File: 17131

August 1, 2017

## RE: STRATTON WOODS, RESPONSE TO PEER REVIEW COMMENTS

# BUILDING SITE EROSION CONTROL

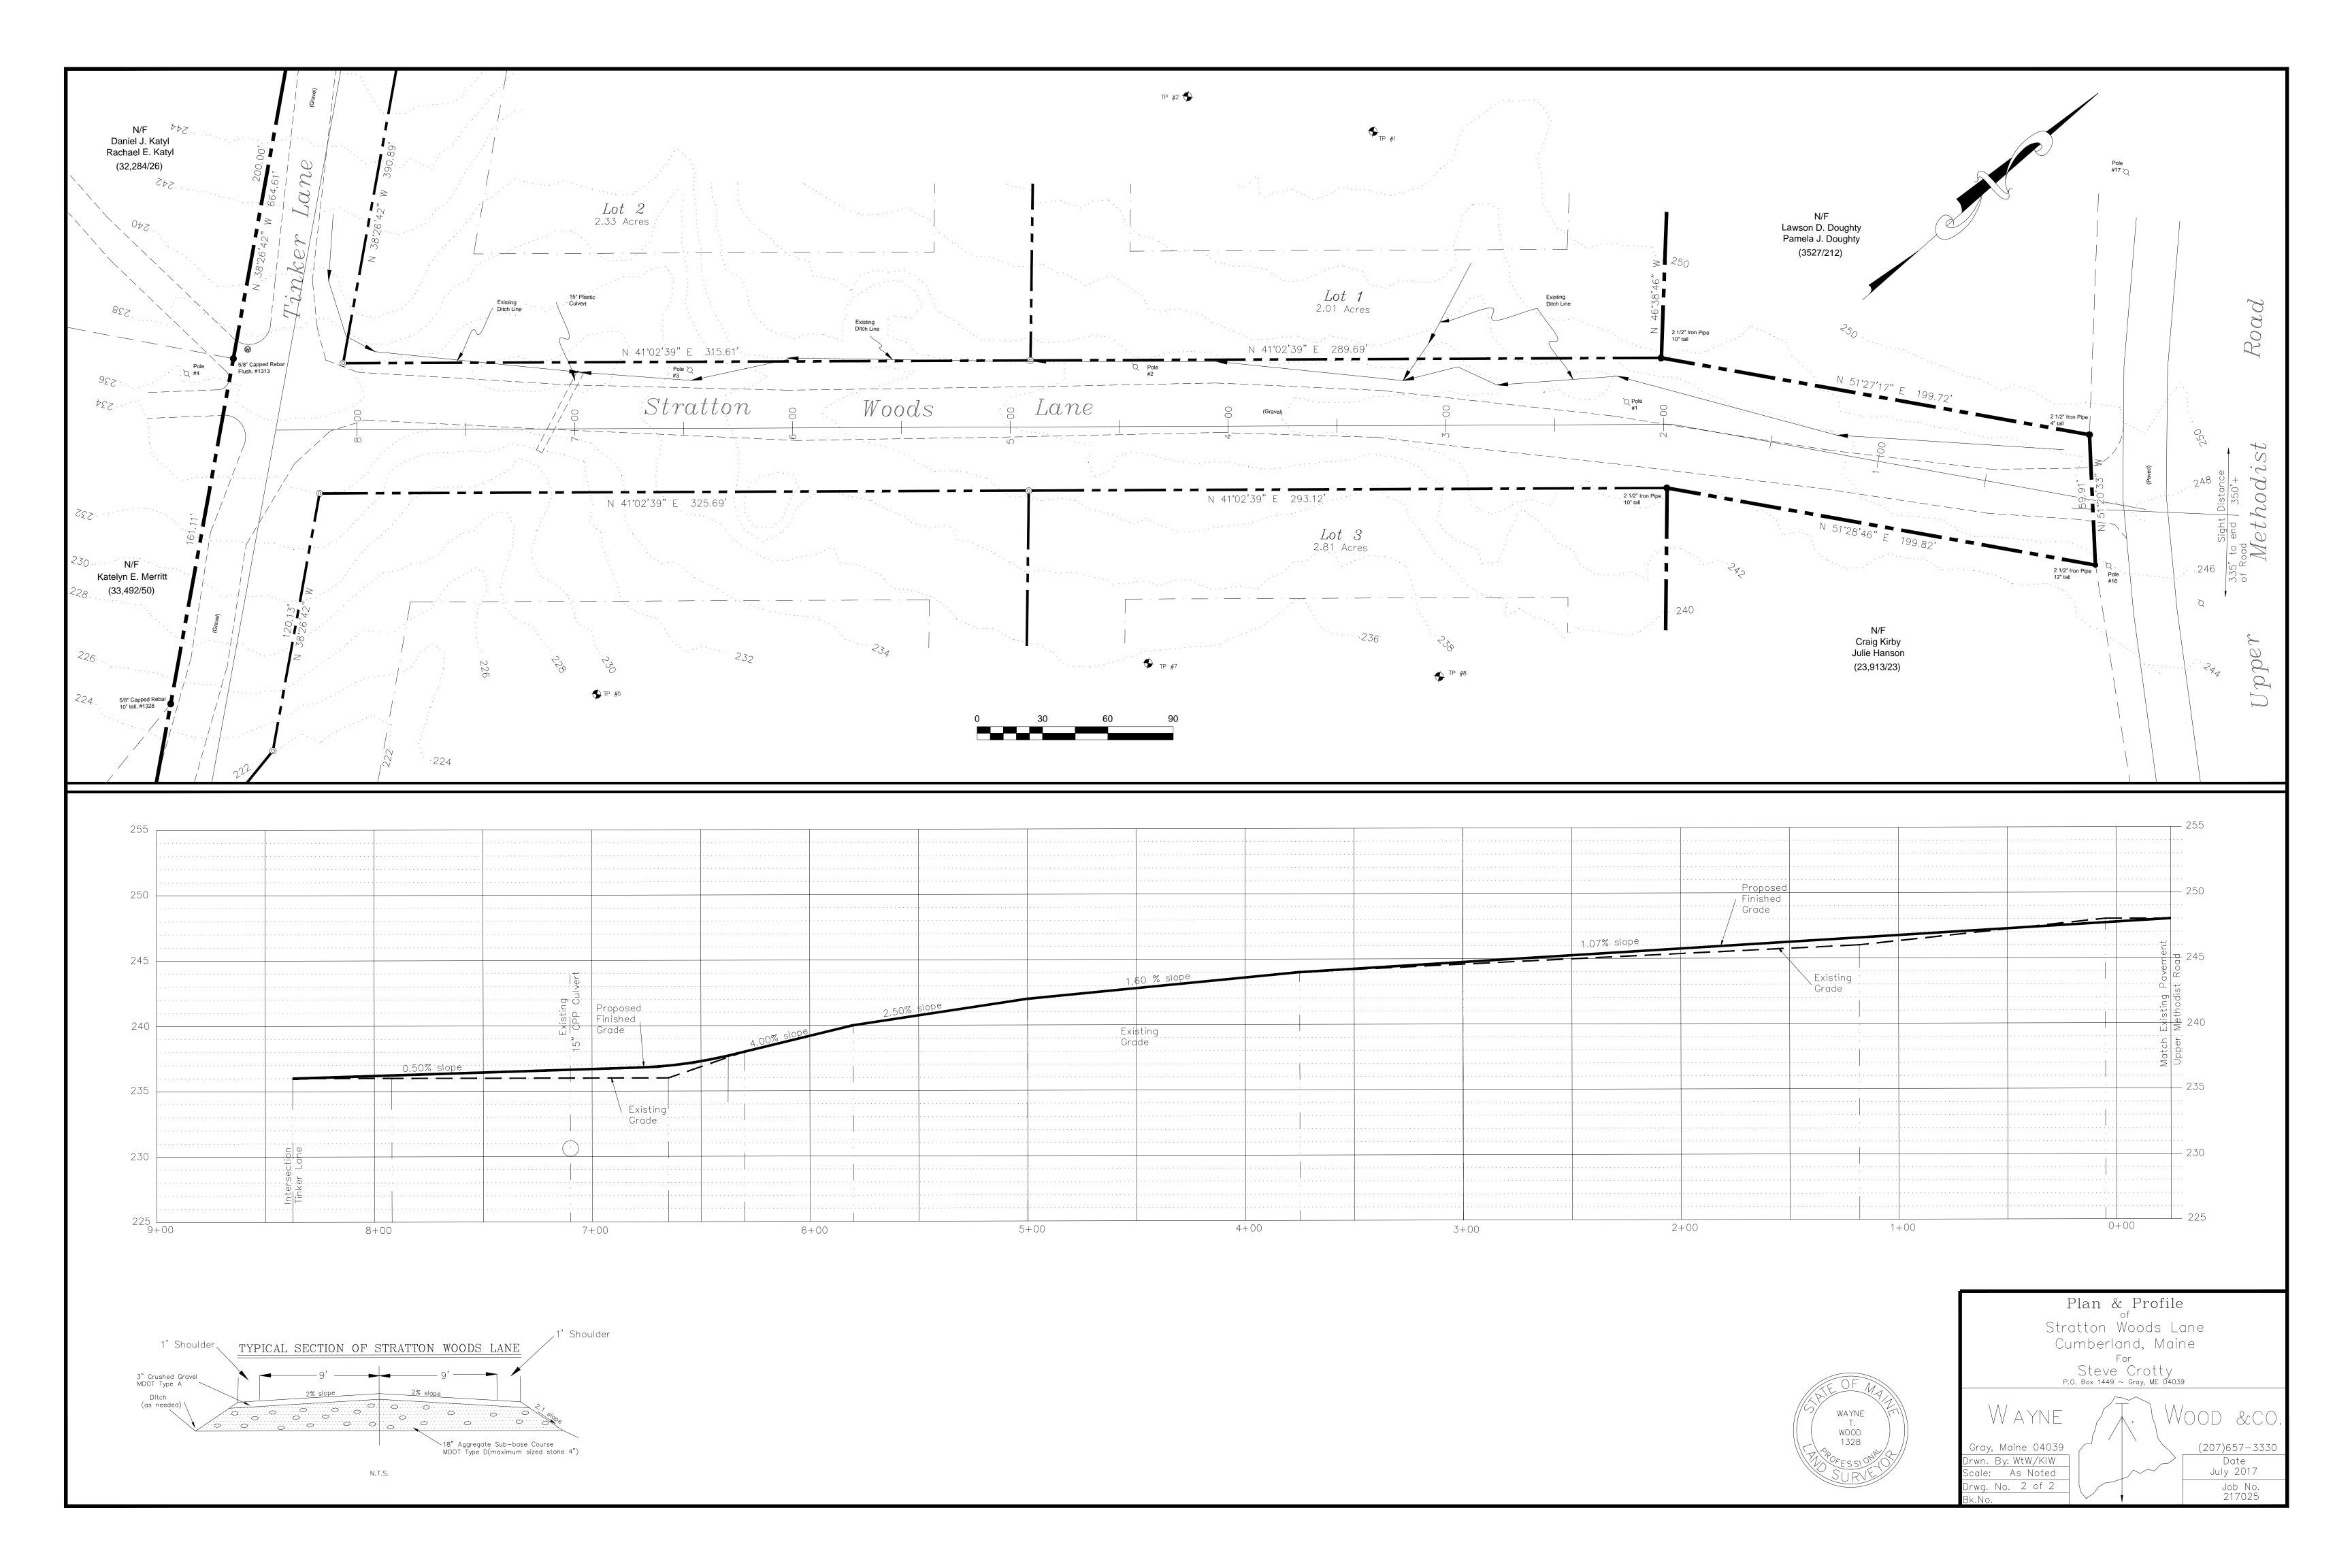
Attached is an Erosion Control Plan for the home construction.

THIS SKETCH INDICATES THE INTENT OF THE SOIL EROSION MEASURES. ACTUAL SITE CONDITIONS AND LAYOUTS WILL VARY FROM SITE TO SITE.

BUILDING CONTRACTORS MUST COMPLY WITH THE EROSION CONTROL NOTES SHOWN ON THESE DRAWINGS AND WITH "MAINE EROSION AND SEDIMENT CONTROL HANDBOOK FOR CONSTRUCTION: BEST MANAGEMENT PRACTICES".

- A INSTALL SILT FENCE OR EROSION CONTROL BERM BELOW ALL DISTURBED AREAS.
- B KEEP CLEARING TO A MINIMUM.
- C RESEED ALL DISTURBED AREAS.
- D INSTALL STONE CHECK DAM(S) AND RIPRAP APRONS DOWNSTREAM OF CULVERT AS NECESSARY.
